Independent Environmental Audit 5

Griffith Base Hospital

SSD-9838218, NSW

July 2024

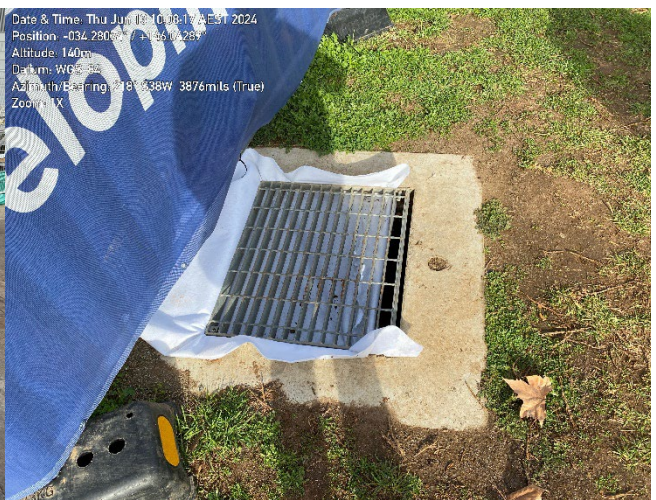
Soil stockpile at contractor parking within 3 m drip line of trees.
